September 25, 2023  
ADDENDUM NO. 4

**SEALED BID #MWJ-TR2404 - BIOLOGY LABORATORIES BUILD-OUT  
for TRUMAN COLLEGE**

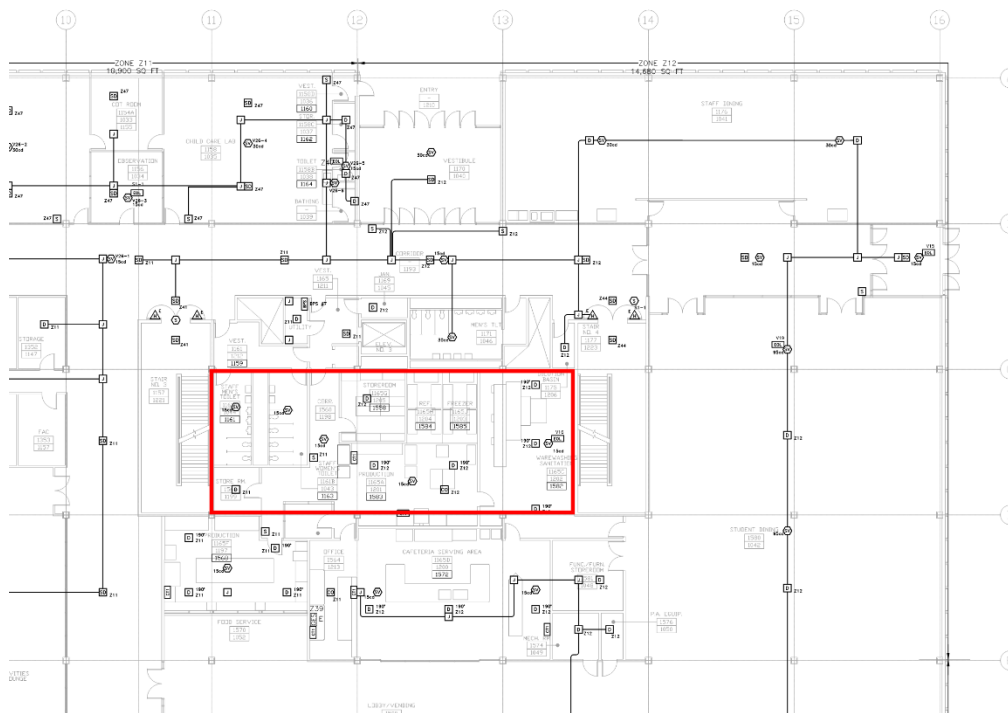
Q6 Although not noted on the Architectural or Demo plans, the ceiling on 1st floor below (which has considerable demo and new plumbing and gas lines) is in the College’s Food Prep /Food Service/Cafeteria area.

Q6.2 In addition, in the food prep area the existing ceiling is spline and in very bad condition. Our opinion is that this portion of the ceiling cannot be removed and reinstalled; it must be replaced. What type of new ceiling should be figured for in the areas where the ceilings cannot be re-used due to its existing poor condition?

**A Demolish and dispose of the Kitchen area ceiling and hangers Rooms: Warewashing sanitation, Dilution Basin, Freezer, refrigerator, Storeroom, Production, Staff Women’s toilet, Corridor, Staff Men’s toilet and Store Room (See area outlined in red below), Provide 24”x24” Class “A” commercial kitchen ceiling tiles Armstrong Ultima Health Zone or similar by USG or Certainteed. Provide a coordinating 1” nominal white finished standard 2’ x 2’ ceiling grid by the same manufacturer as the ceiling tile or by Chicago Metallic. Sprinkler work, diffusers, light fixtures, controls, security cameras, exhaust fans and all other items affixed to the existing ceiling shall be removed as necessary and reinstalled in the new ceiling., The entire first floor affected area shall be protected and sanitized upon construction completion. Date and time of all trades working in this area shall be coordinated in advance with the school engineer and City College of Chicago.,and shall be time compressed to minimize disruption.**

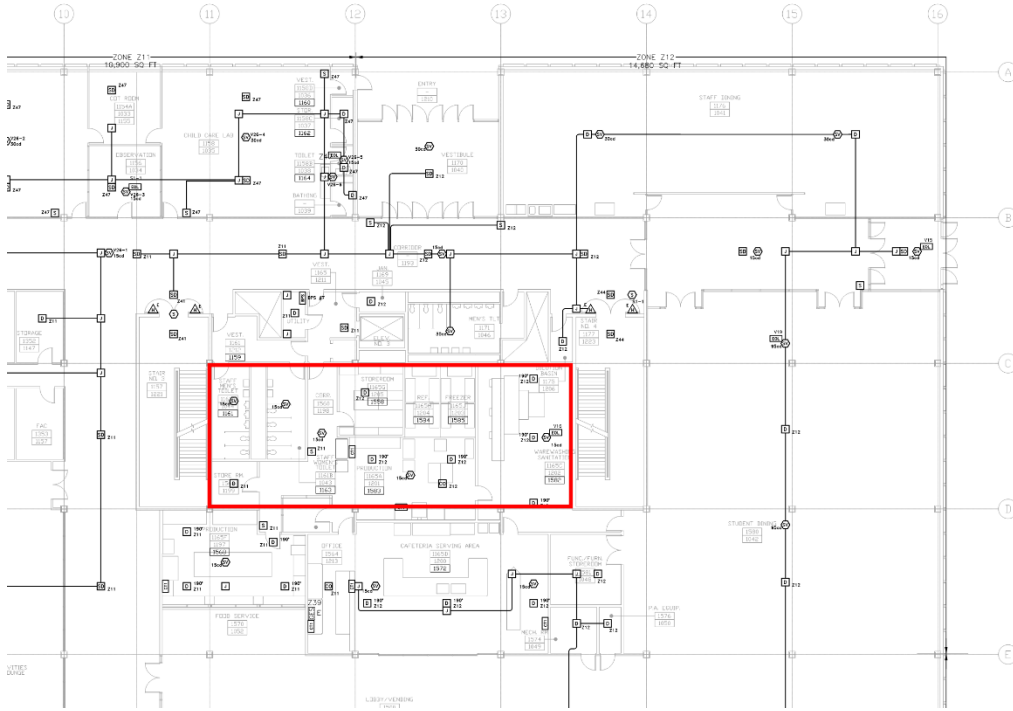
**ITEM NO. 1 – Add and include the following in your bid response (see also in this Addendum Q6 questions and responses):**

### **Demolish and dispose of the Kitchen area ceiling and hangers Rooms:**

Warewashing sanitation, Dilution Basin, Freezer, refrigerator, Storeroom, Production, Staff Women's toilet, Corridor, Staff Men's toilet and Store Room (See area outlined in red below), Provide 24"x24" Class "A" commercial kitchen ceiling tiles Armstrong Ultima Health Zone or similar by USG or Certainteed. Provide a coordinating 1" nominal white finished standard 2' x 2' ceiling grid by the same manufacturer as the ceiling tile or by Chicago Metallic. Sprinkler work, diffusers, light fixtures, controls, security cameras, exhaust fans and all other items affixed to the existing ceiling shall be removed as necessary and reinstalled in the new ceiling., The entire first floor affected area shall be protected and sanitized upon construction completion. Date and time of all trades working in this area shall be coordinated in advance with the school engineer and City College of Chicago; and, shall be time compressed to minimize disruption.
